Typical details: where CAD and Revit draw the same detail differently

55 of the 190 CAD typical details have a Revit version in your templates that is drawn differently.

Compared by eye on 2026-10-23 from Nelson's CAD blocks and the Concrete Tower R24 / Steel R24 / Container R23 templates.

Revit: 1E1.05_14_TYPICAL ARCHITECTURAL SITE WALL (Kor_Concrete_Tower_Project_Template_Arch D E1 E_R24 (Do Not ; on 1E1.05 TYPICAL DETAILS)

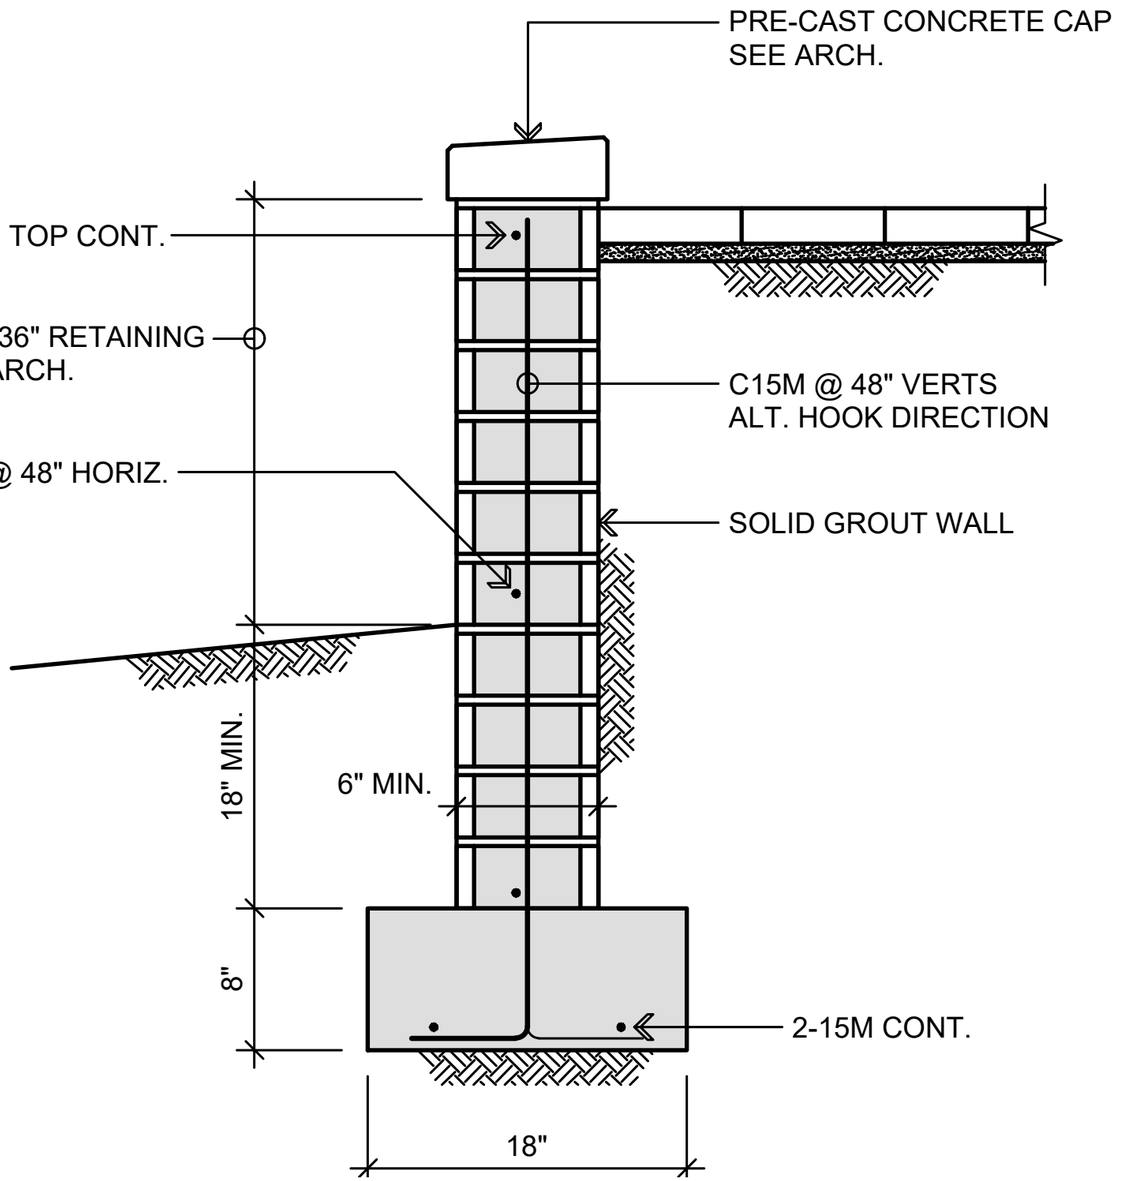
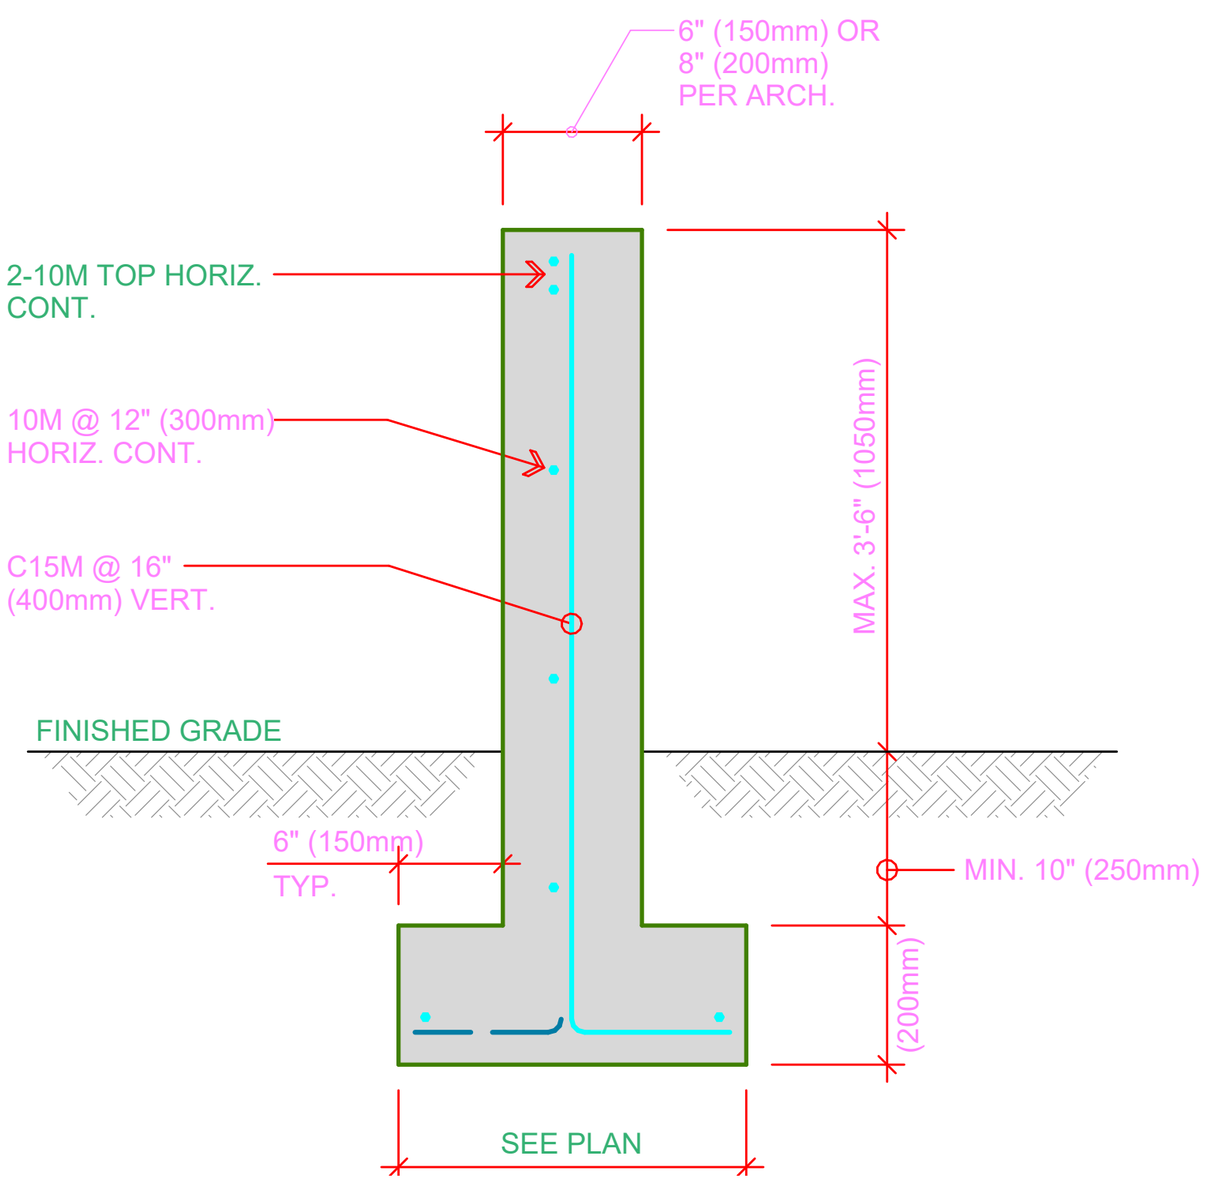
What differs: Both low site walls on footings, but CAD is a grouted masonry retaining wall with precast cap, Revit a concrete wall.

CAD: KOR-D502-DET 34 - BUILT-UP SLAB DETAIL

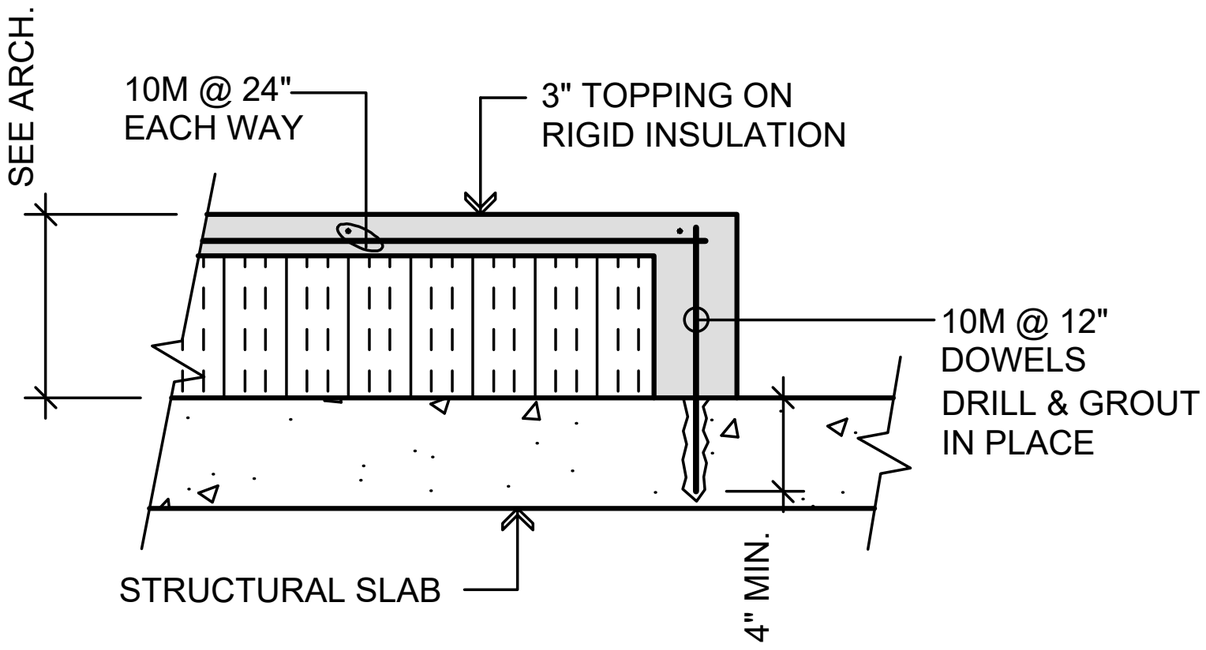
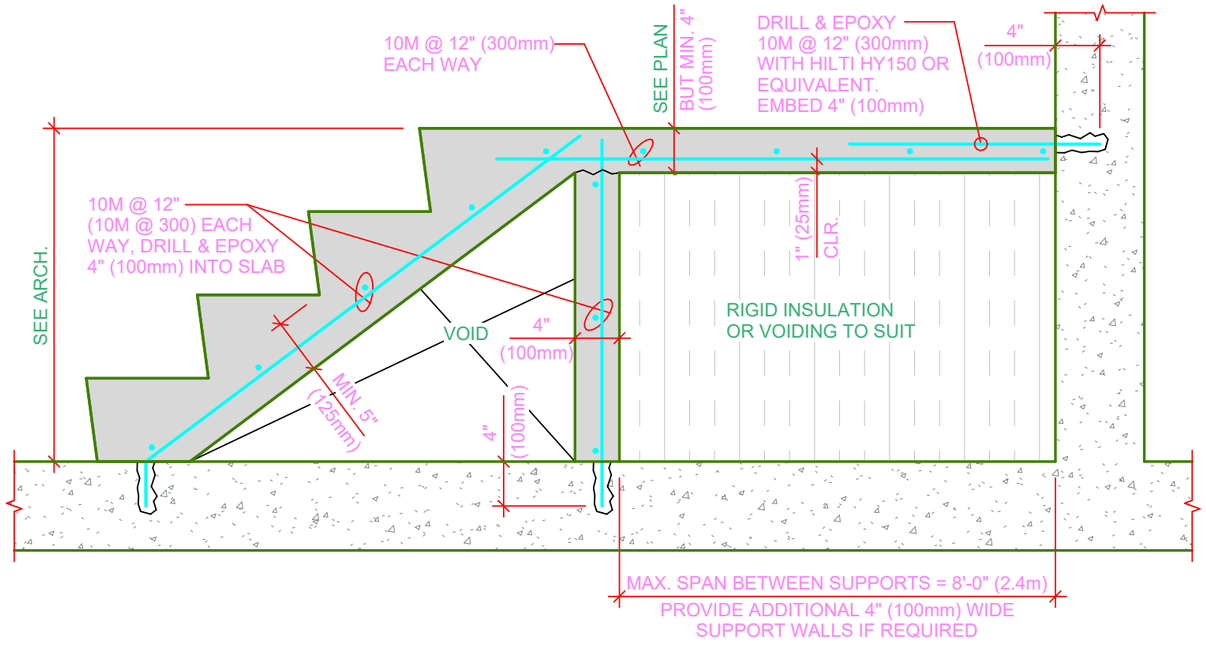
What differs: Both built-up slabs with rigid insulation, but CAD is topping on insulation with dowels, Revit a stepped fill with support walls.

Revit: D5.02_7_SANDWICH SLAB DETAIL (Typical Details - Container_R23 (Need_MET & IMP).rvt; on D5.02 Series 5 Miscellan)

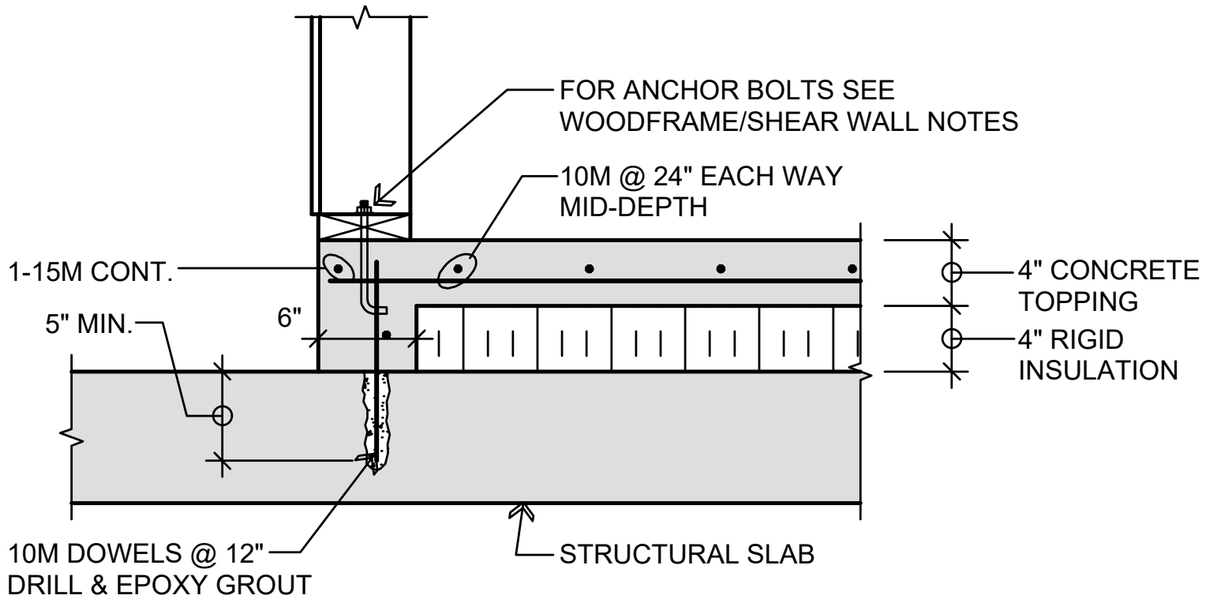
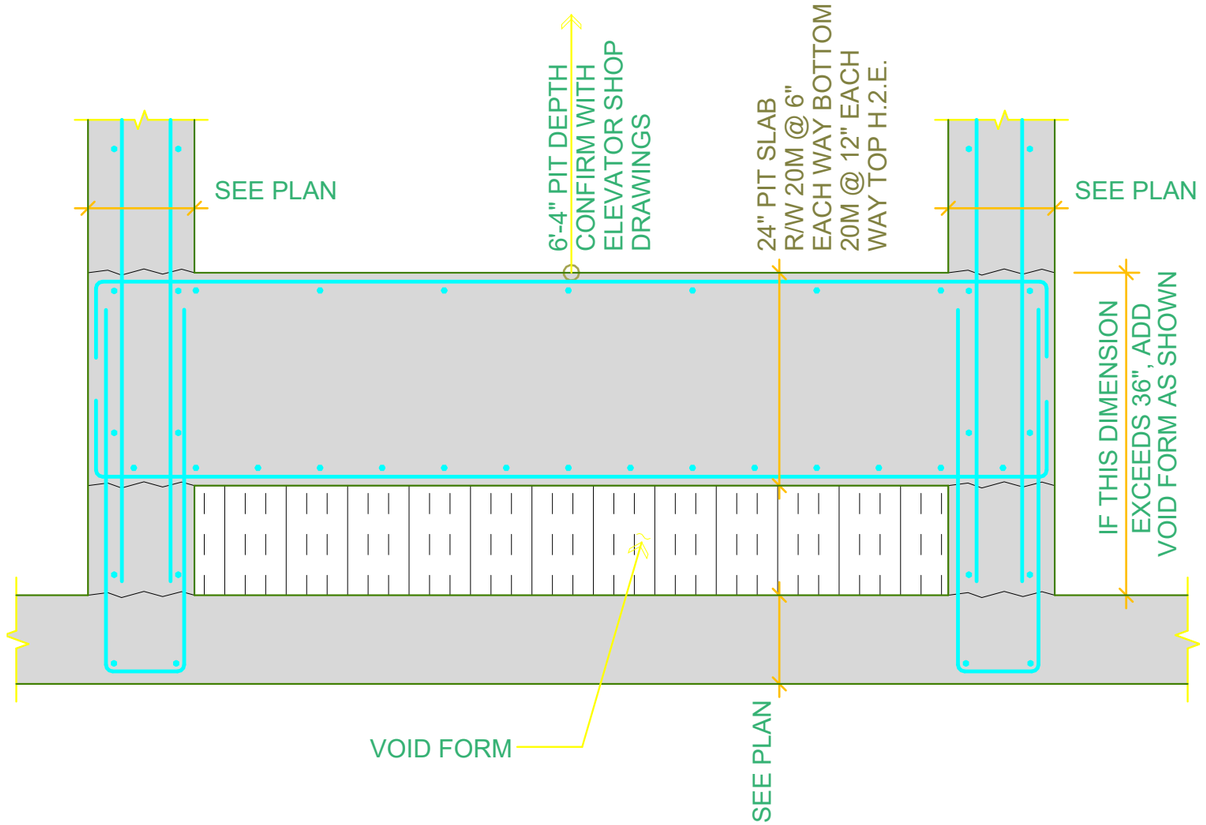
What differs: Same title, but CAD is topping on rigid insulation over structural slab, Revit a slab over void form at a pit.

CAD: KOR-D504-DET 06 - DOWNTURN DETAIL

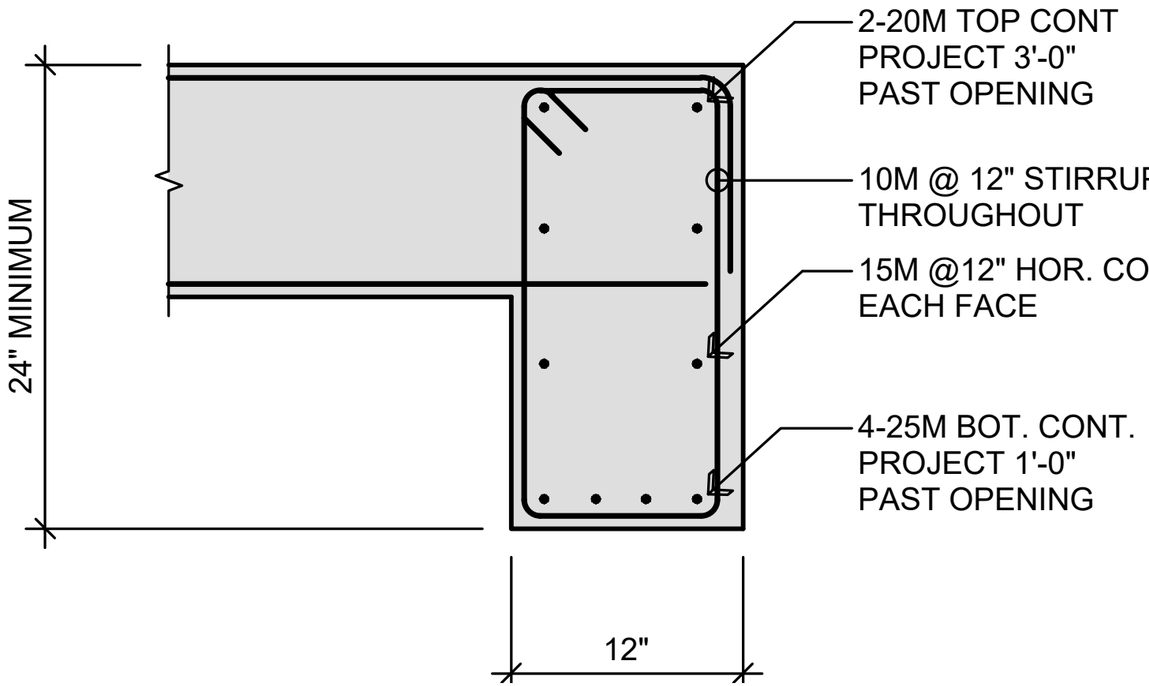
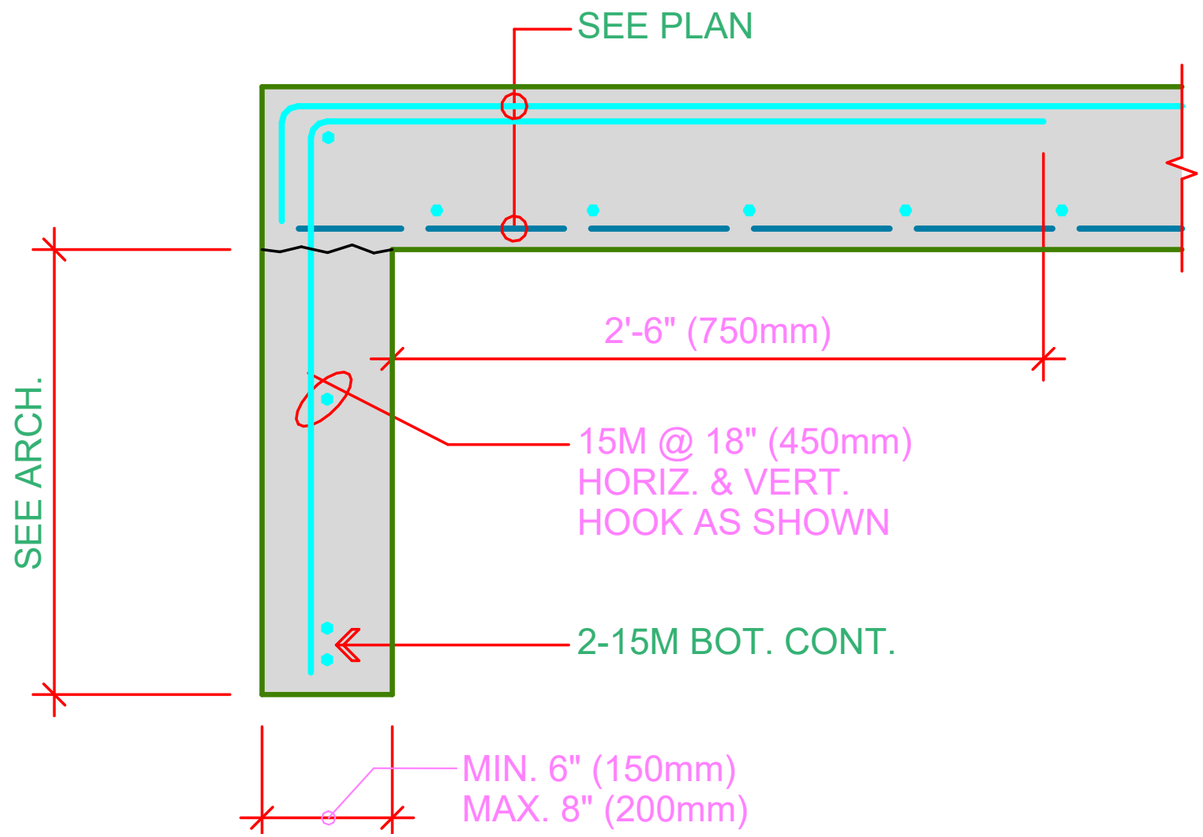
What differs: CAD is a 24in-min downturn beam with stirrups, 2-20M top and 4-25M bot projecting past an opening; '1E1.04_13_TYPICAL DOWNTURN' is a thin 6-8in downturn wall with 15M @ 18in.

CAD: KOR-D504-DET 07 - DOWNTURN DETAIL

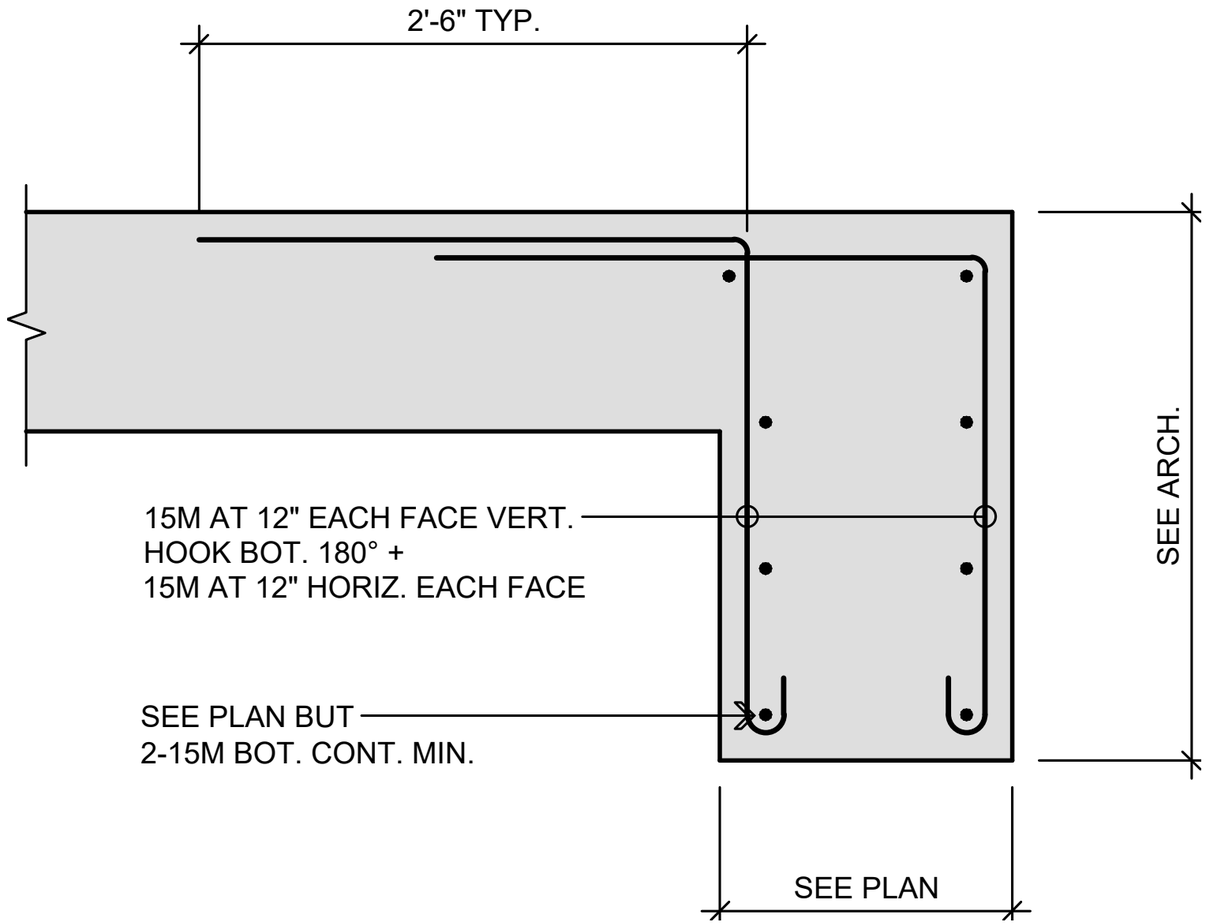
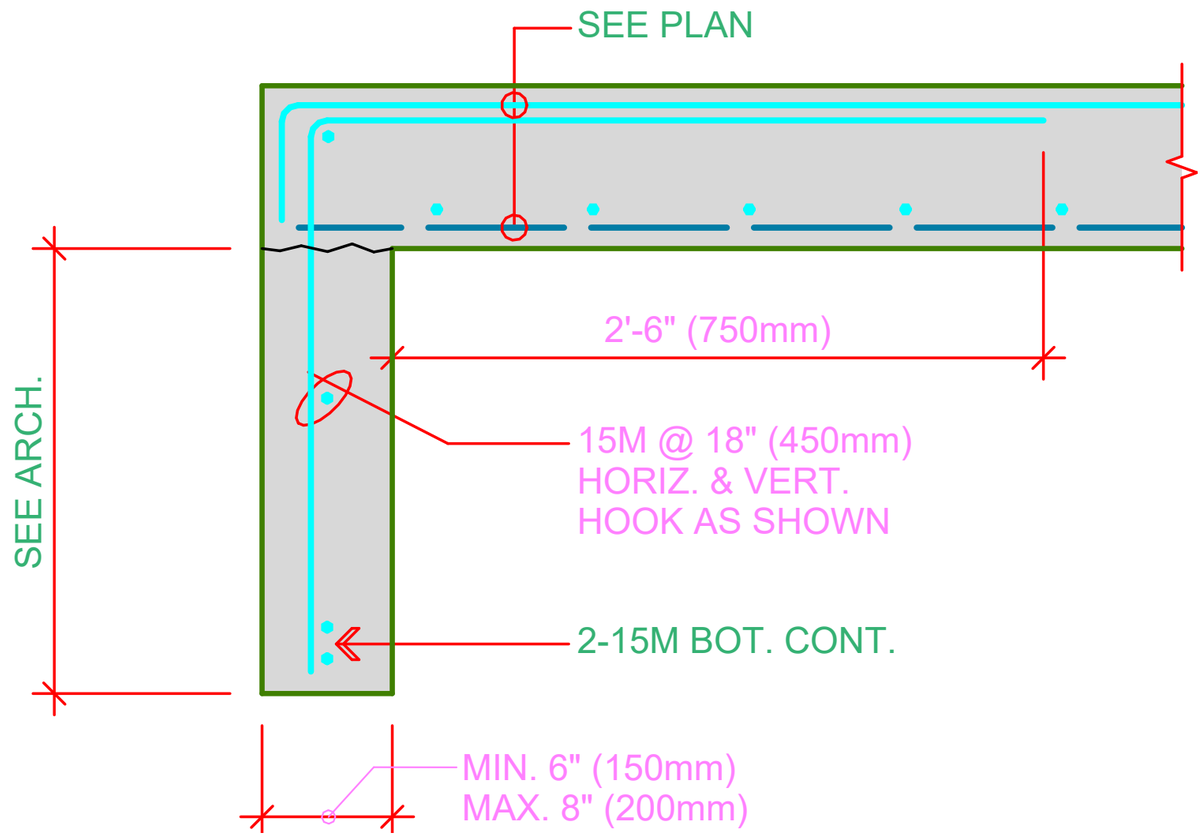
What differs: Same 2'-6in slab-edge downturn idea, but the CAD uses 15M @ 12in each face and a wider section; '1E1.04_13_TYPICAL DOWNTURN' uses 15M @ 18in.
